Canterbury Earthquakes Royal Commission

CCANZ Submission

Critique of

- “CTV Site Examination and Materials Tests Report”

**Column Test Strength Distribution.
Special Grade Concrete versus High Grade Concrete aged 25%**

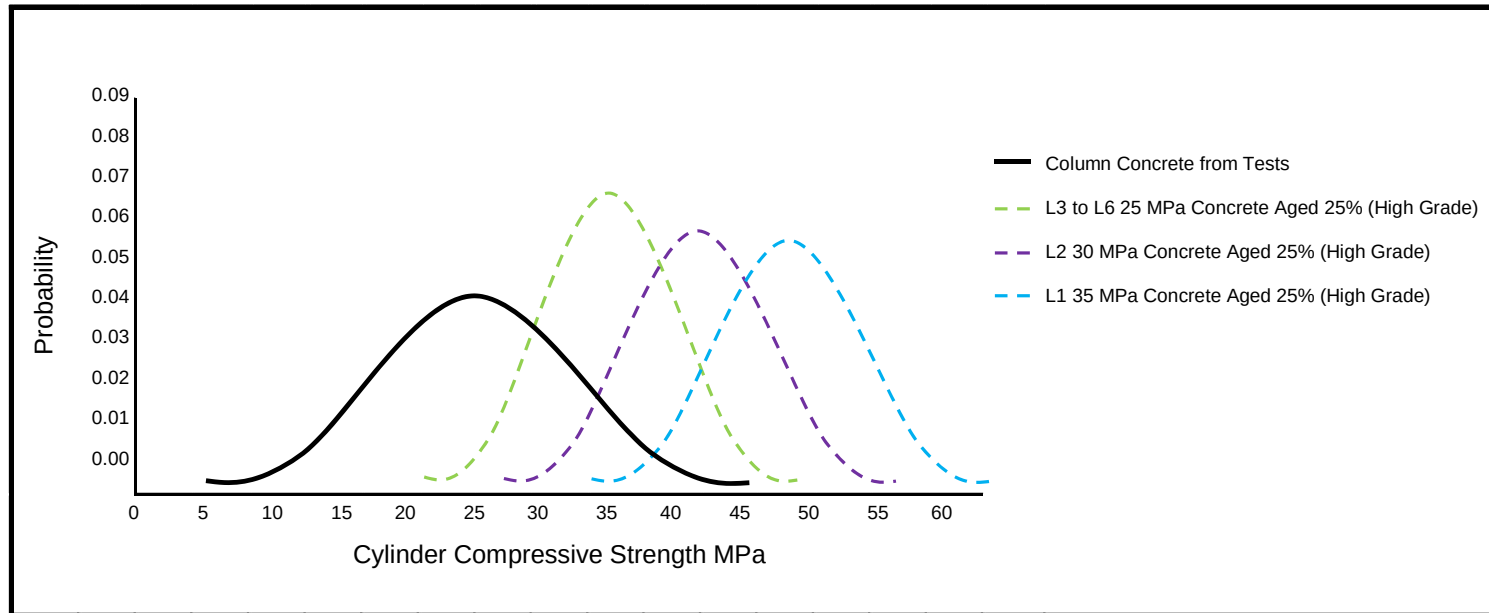
- Incorrect application of concrete aging
- High Grade vs. Special Grade

- Hyland Reports' concrete core testing methodology not best practice
 - o Testing objective not clarified
 - o Cores taken from distressed concrete
 - o Issues around core diameters, number and location
 - o Incorrect application of concrete aging
 - o Schmidt Hammer test – insufficient number and poor sample
- Hyland Reports' conclusions re concrete column strength must therefore be questioned
